**Re: 144 Fore Street : Change of Use to Professional Offices (for VA Medical Office),
Building Renovation and Minor Site Plan
Applicant: Jackrabbit, LLC
Application # (HTE) 10-79900012**

RE: 144 Fore Street: Change of Use to Professional Offices (for VA Medical Office),
Building Renovation and Minor Site Plan Application

Re: 144 Fore Street Building Renovation and Minor Site Plan
Portland, Maine
Application # (HTE) 10-79900012

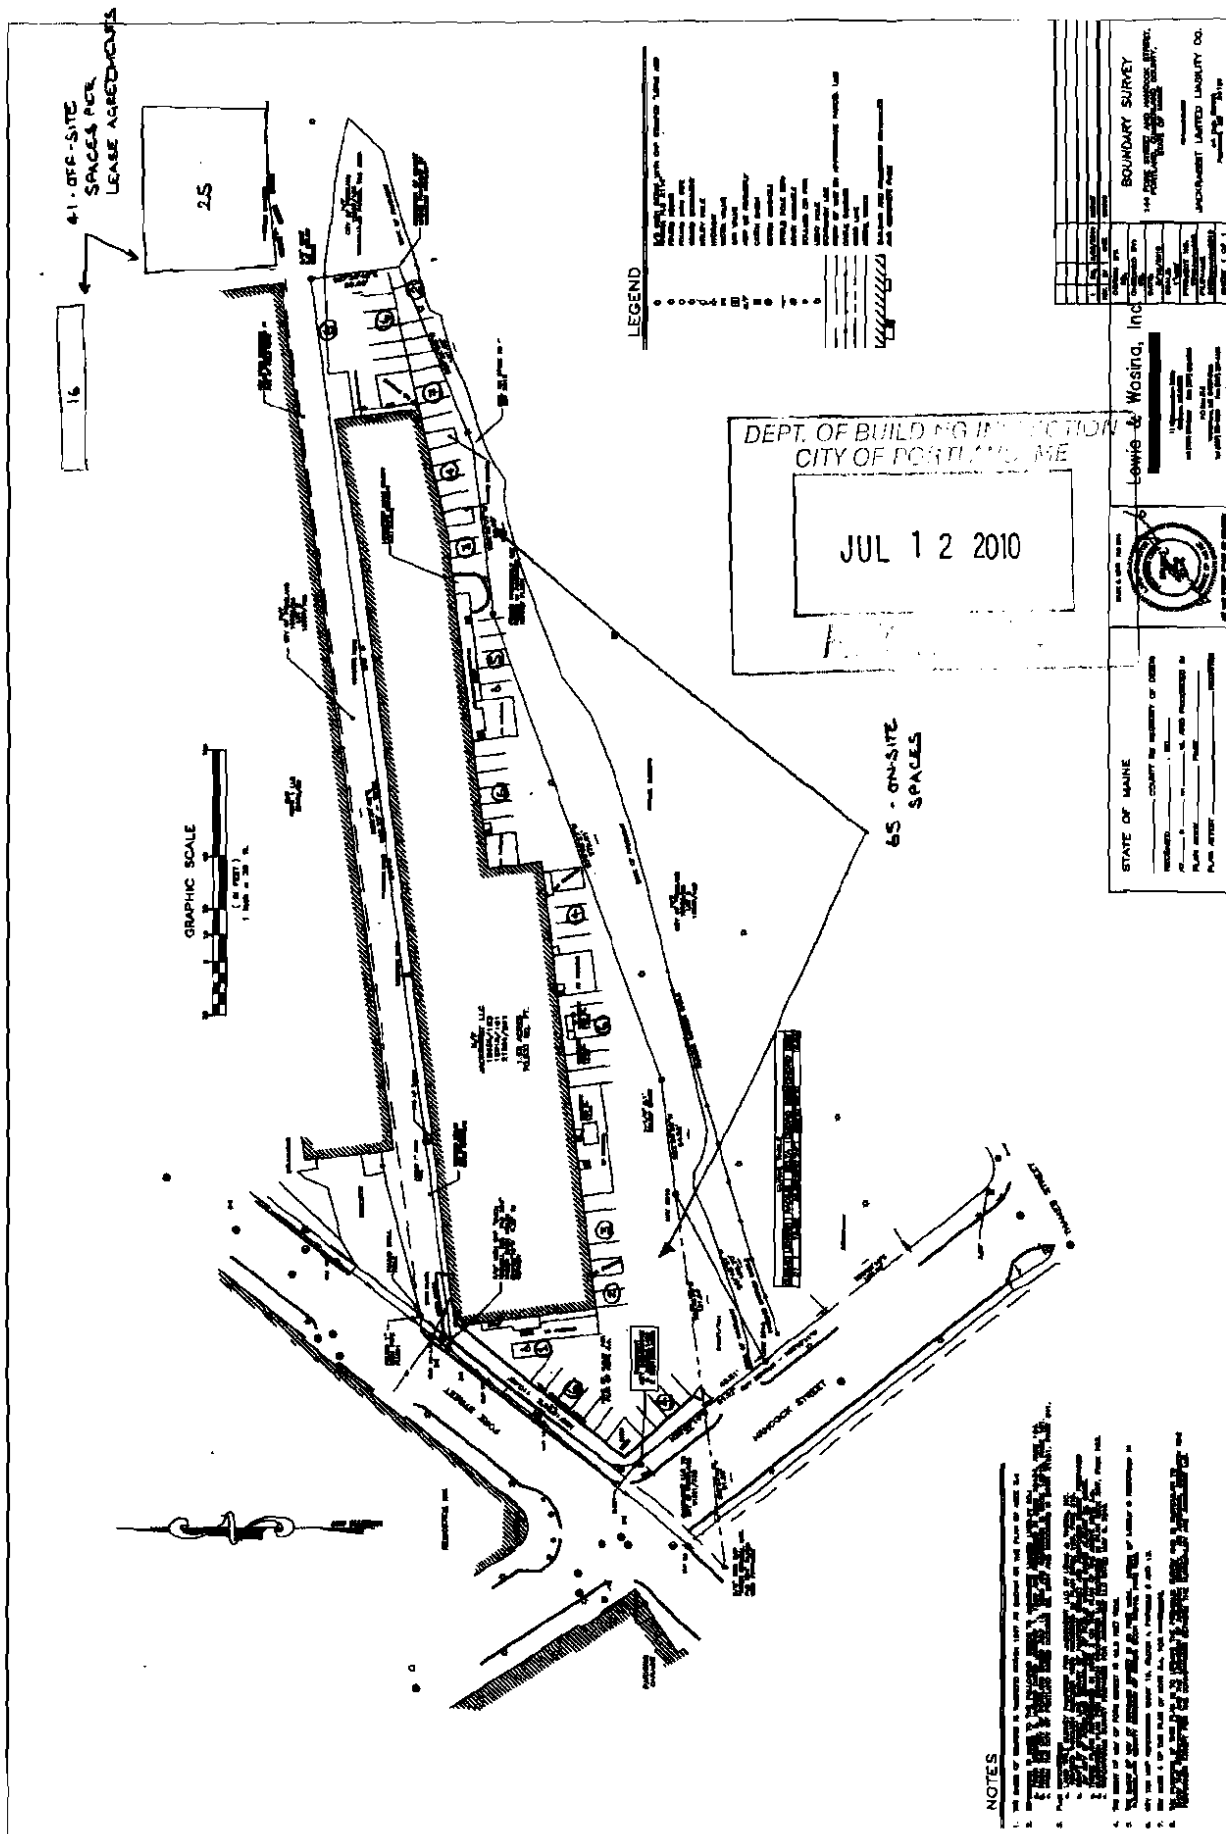
Could you please clarify (show on plan) the number and location of the Cacoulidis parking spaces and the number and location of the City spaces as referred to in the submitted leases.

A sketch showing the parking numbers used in the analysis for the entire building is attached for your review.

1444 FORE STREET
STONEMASTER DRAINAGE
PATTERN SKETCH
ADD 07-26-10

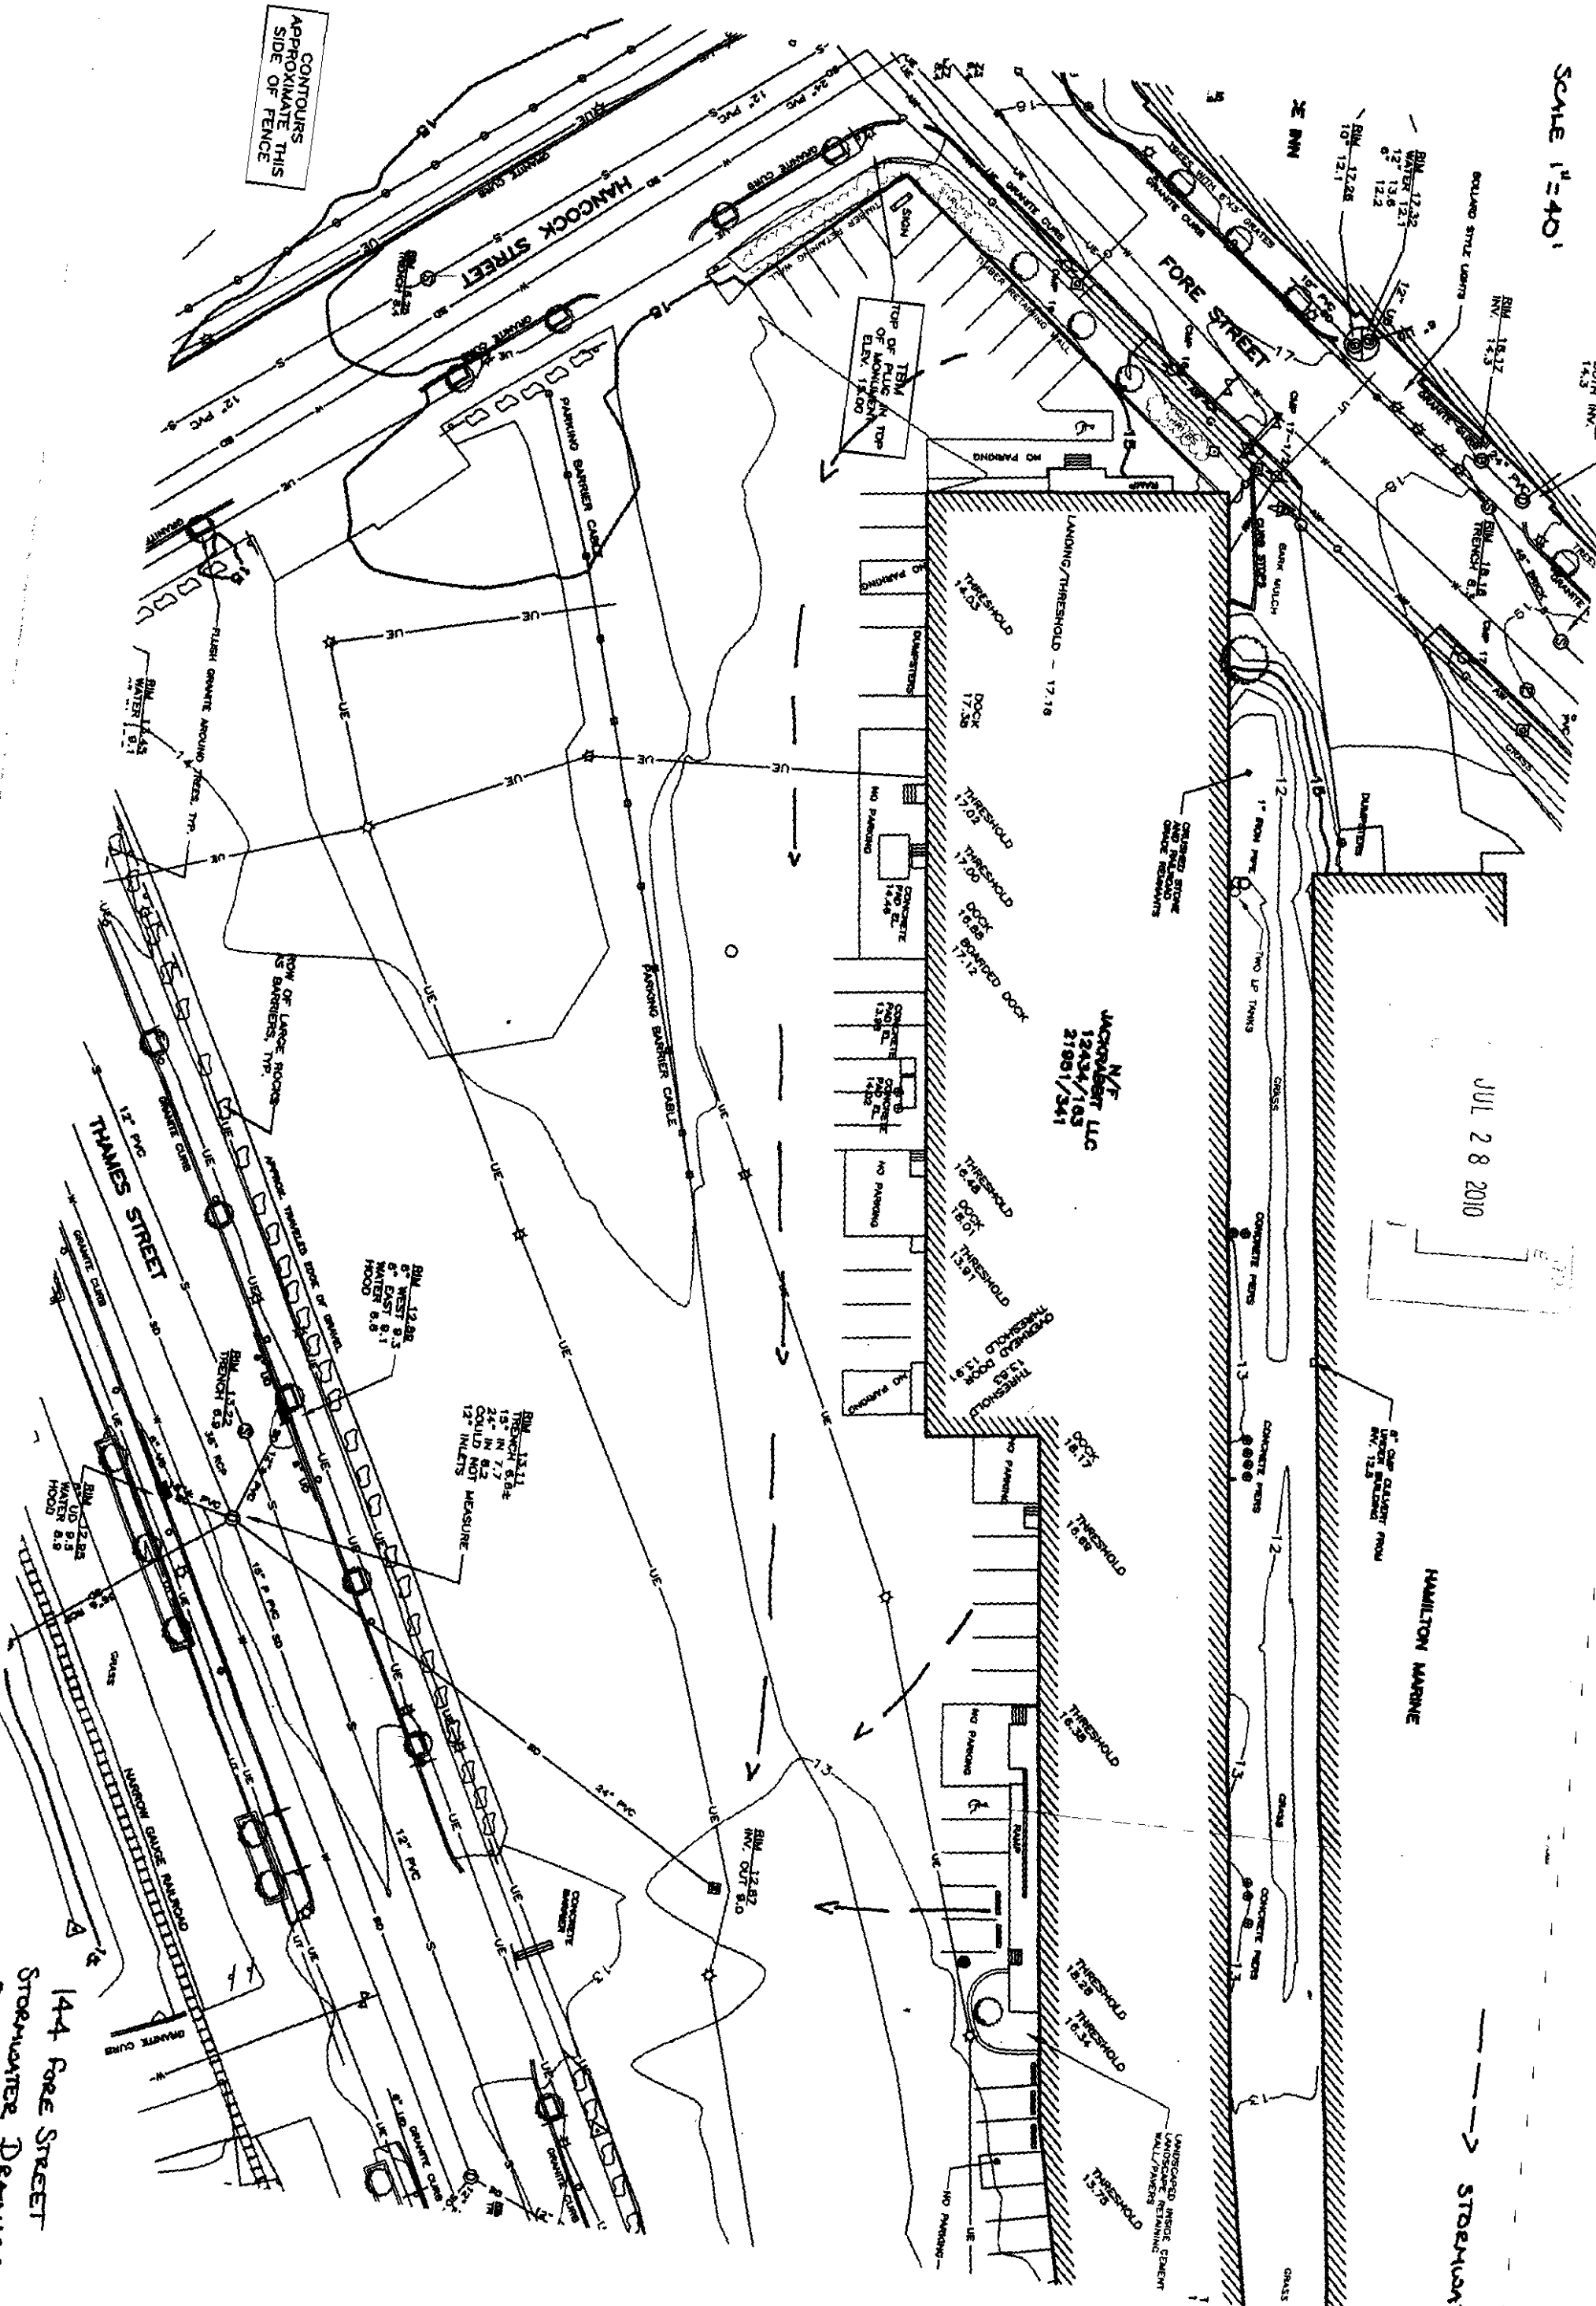
4. **Drainage:** There is a general note on the Site Layout Plan that states "*Remove and replace existing bituminous pavement.*" Please show the precise extent of pavement replacement. The Department of Public Services requests that the submissions also show site surface drainage, and that the applicant should consider applying some means of stormwater treatment.

Response: The existing pavement will be milled and overlaid, maintaining the existing grades and drainage patterns. There is no plan to re-construct the entire pavement structure and/or alter the grades and drainage patterns on the site. The area currently drains by sheet flow towards a catch basin on the adjacent city parking lot. This is shown on the survey plan, and a sketch showing general flow paths is included for your review. No provision for additional stormwater capture and treatment is planned as part of this project.

25 ton Trane packaged rooftop - Model YCD300E
Insultech Compressor Wrap
Distance to Receiver: 20 ft source to ground, 5 ft receiver to ground and 43 ft source to receiver

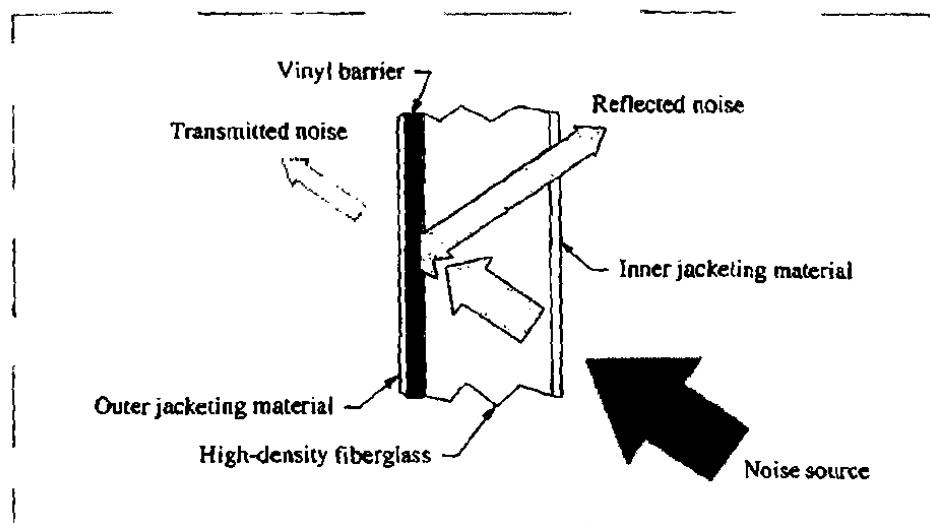
- iii. *That the applicant shall submit documentation, to the satisfaction of the Zoning Administrator prior to the issuance of a building permit, to confirm that the cumulative noise levels of the external HVAC and any other exterior mechanical equipment comply with the noise standards of the B6 Zone, where the maximum permissible sound levels for the HVAC units are sixty (60) dBA between the hours of 7:00 a.m. and 10:00 p.m. and fifty (50) dBA between the hours of 10:00 p.m. and 7:00 a.m. as measured at or within the boundaries of any residential zone.* **Response: HVAC equipment for the renovated space has been consolidated into one unit, which will be mounted on the roof in a location central to the space, providing maximum separation from the surroundings at all locations. The unit will incorporate acoustic blanket insulation. The combined effect of the blanket plus distance from the nearest property boundary (required measuring point per B6 zoning) is a reduction in sound level of the unit of 37 dBA (this is conservative and could be as high as 41dBA according**

TRANE Acoustic Blanket System

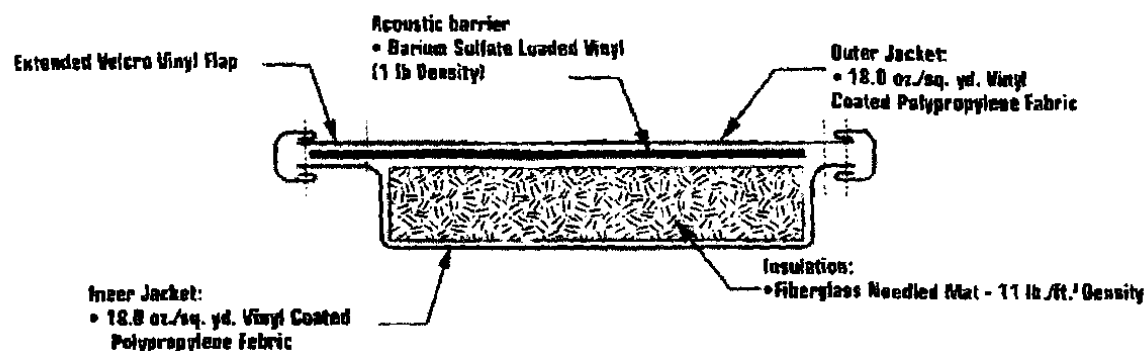
- iv. *That the details (including dimensions and materials) of any proposed sound baffles, shielding, or other enclosures for the HVAC and any other roof equipment, shall be submitted for review and approval by the Planning Authority prior to the issuance of a building permit. Response: Please see response above. No other rooftop equipment is proposed. No other sound attenuation measures are proposed other than the acoustic blanket attached herein.*

Point-by-point Plan

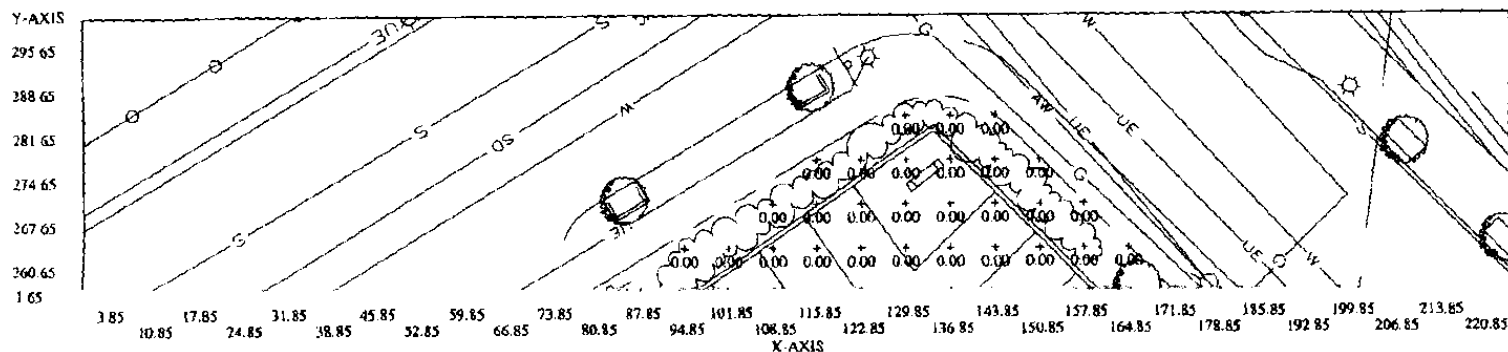
- vi. *That a photometric plan shall be submitted prior to the issuance of a building permit to document that the proposed wall mounted lighting on the west elevation (as measured without including the ambient light from the street lights) meets the City Lighting Standards regarding maximum light levels. Response: Light levels for the four proposed wall-mounted light fixtures was modeled in a point-by-point plan without inclusion of surrounding street fixtures. Average illumination and light level at the property line fall within city standards. Light levels immediately under the fixtures are predictably slightly higher than the 5 fc maximum as can be expected given the mounting heights and types of fixtures. Please refer to the attached lighting plan.*
